Converting from 93xx46 Devices to 93xx46A/B Devices

AN664

PRODUCT CONVERSION DECISION TREE

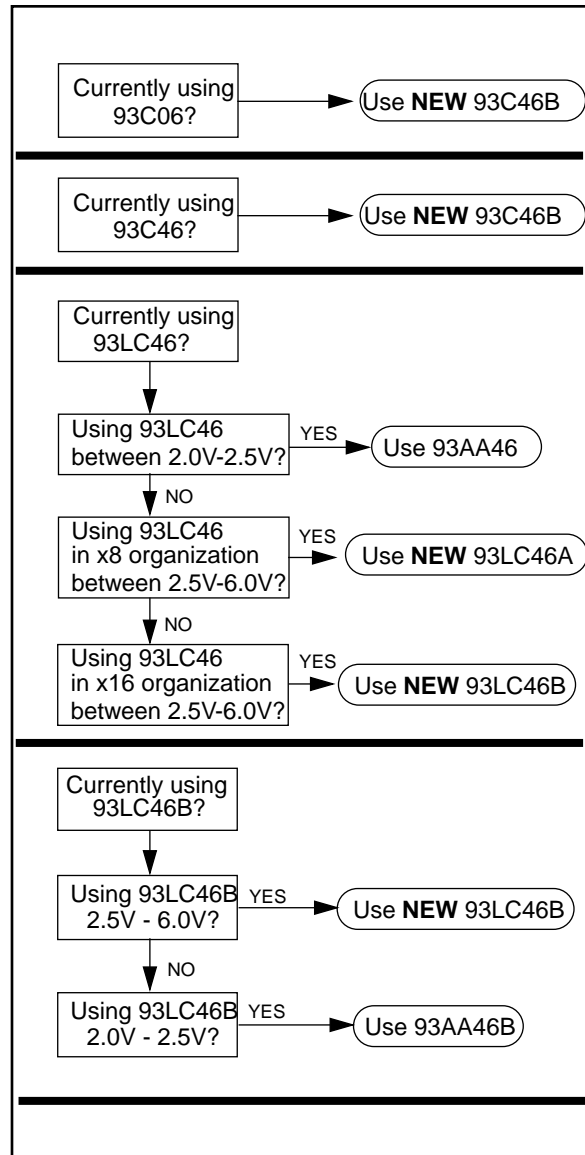
The following product conversion decision tree will assist in converting to the new 93xx46A/B products. In order to properly convert to new products two items need to be known about the existing application, the operating voltage of the system and whether the memory is organized as x8 or x16. Once that information is known then the decision tree will assist in determining what the new product should be. The product selection is also available in tabular form on page 2.

VOLTAGE OPERATION GRAPHS

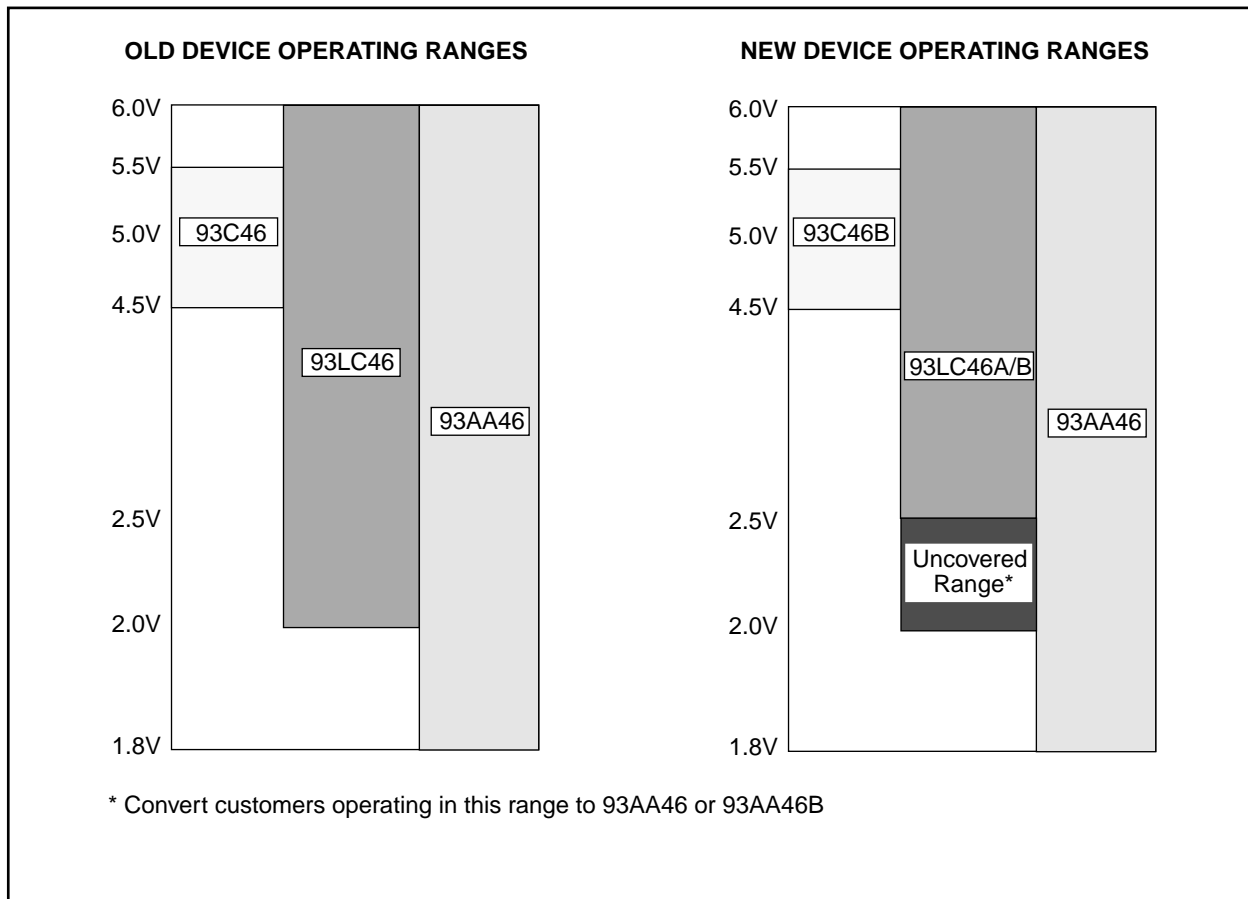
The following two graphs show the operating voltages of the current 93xx46 devices and the **NEW** 93xx46A/B devices. From the graphs it can be seen that there is a voltage range covered by the existing devices that is not covered by the new devices. The continued production of the 93AA46 device ensures that anyone currently operating in the voltage range not covered by the new 93xx46A/B devices will have a conversion solution.
